MILITARY SPECIFICATION
INDICATOR, TEMPERATURE, THERMOCOUPLE
EHU-38/A

This amendment forms a part of Military Specification MIL-I-83262/2(USAF) dated 25 May 1977.

FIGURE 2. Subdial pointer.

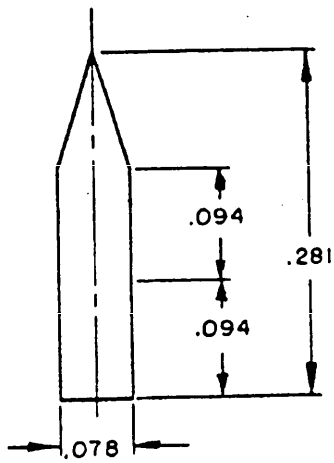
3.7.2: Delete and substitute:

Add Figure 2.

"3.7.2 Subdial pointer. The subdial pointer shall be as shown on figure 2. The minimum lighted length of the pointer shall be 0.187 inch. The lighting shall be in accordance with MIL-L-27160. The length of the pointer is the distance from the tip to the center of the pivot point. The pointer may be constructed in such a way as to have an overhang or a hub section which is black. This section shall not be considered part of the specified length of the pointer."
